Re: Energy Conservation for Program: Energy Conservation Standards for Packaged Terminal Air Conditioners and Packaged Terminal Heat Pumps [*Docket Number EERE-2012-BT-STD-0029*]

These comments are submitted by the Air-Conditioning, Heating, and Refrigeration Institute (AHRI) in response to the U.S. Department of Energy's (DOE) notice of proposed rulemaking (NOPR) on the energy conservation standard for Packaged Terminal Air Conditioners (PTAC) and Packaged Terminal Heat Pumps (PTHP) appearing in the *Federal Register* on September 16, 2014.

Figure 1 Impact Analysis of Proposed DOE Minimum Efficiency Levels for PTAC

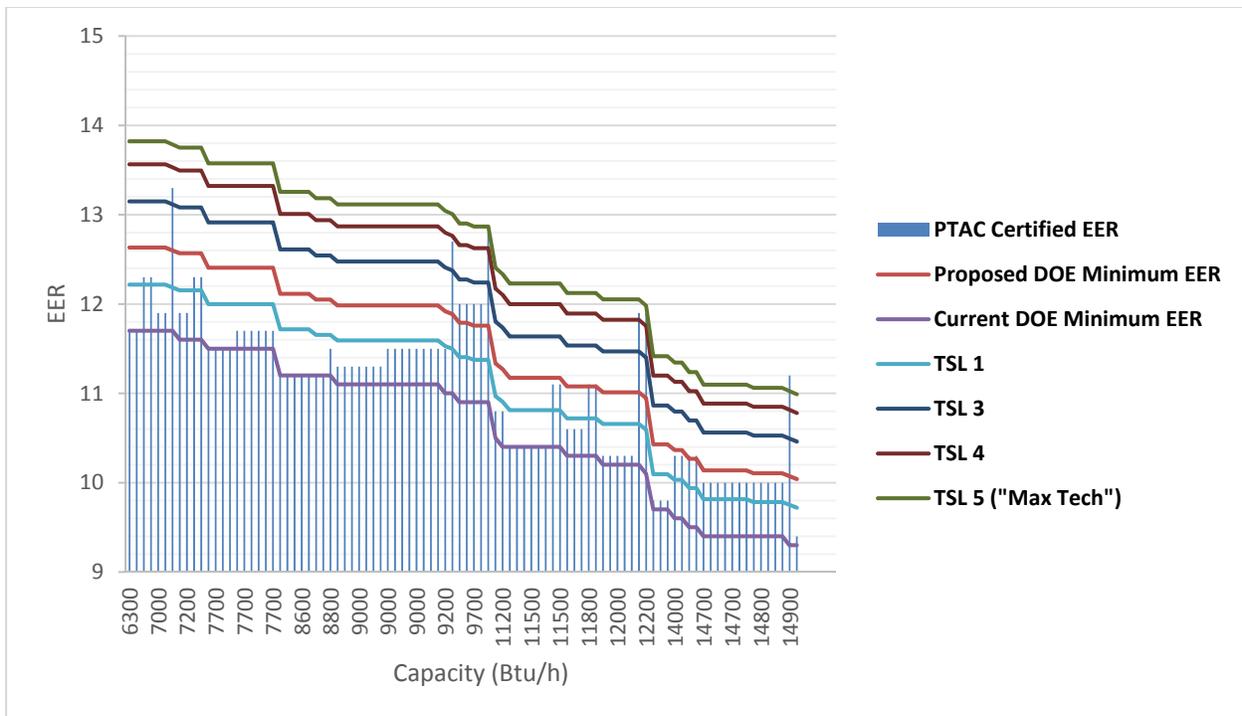
In Chapter 3 of the TSD, DOE combined information from the 2013 AHRI Directory of Certified Product Performance (2013 AHRI directory) with other publicly available data from manufacturer catalogs of PTACs and PTHPs to develop an understanding of the industry. The AHRI Directory contains listing from Original Equipment Manufacturers (OEMs) and Private Brand Manufacturers (PBMs). External users of the Directory are not able to differentiate between OEMs and PBMs because this relationship is confidential. What DOE was not able to capture in their market characterization is that less than one-fourth of the listings belong to OEMs. The number of certified models at each capacity (Figures 3.2.1 and 3.2.2) are significantly inflated by PBM sales. At the October 29th public meeting AHRI presented an impact analysis of proposed DOE minimum efficiency levels for PTAC and PTHP for OEMs.

This same information is presented in Figures 1 and 2, above, for PTACs and PTHPs, respectively, with TSL levels below 7,000 Btu/h and above 15,000 Btu/h corrected to show the leveling off of the minimum EER. It is important to note that this oversight had

Since DOE used the model availability in the Directory, the DOE underestimated the percent of models which actually require redesign and therefore underestimated the industry conversion costs. By AHRI's analysis of the Directory, 85% of all OEM PTAC models and 77% of all OEM PTHP models will require redesign at TSL 2. The DOE did not consider such a significant impact on industry in its analysis and should revise its analysis to reflect this updated and more accurate information.
